SERVICE INSTRUCTIONS

KEATING
OF CHICAGO, INC. ®

Part # 058545

REPLACING PART #032242 (Lighted Rocker Switch) WITH PART #058328 (Non-lighted Rocker Switch)

Model IFM

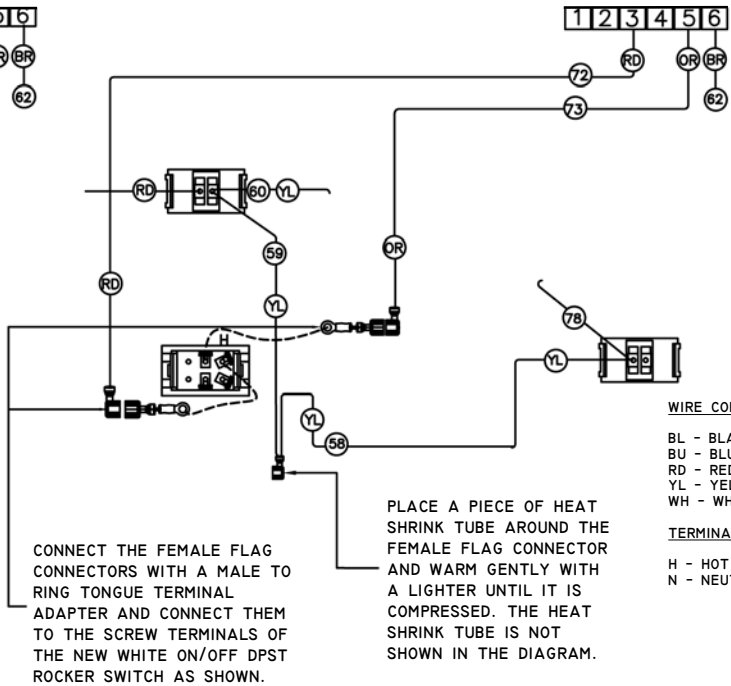
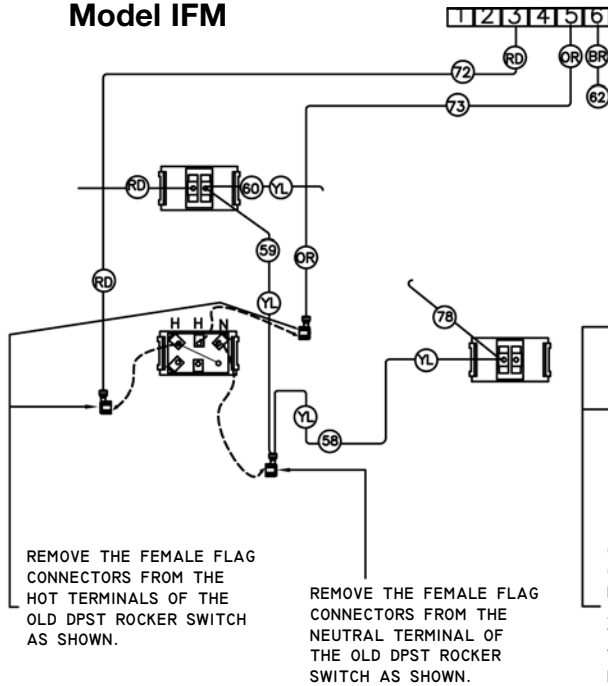
Please select the wiring diagram for your fryer and wire the new switch as shown
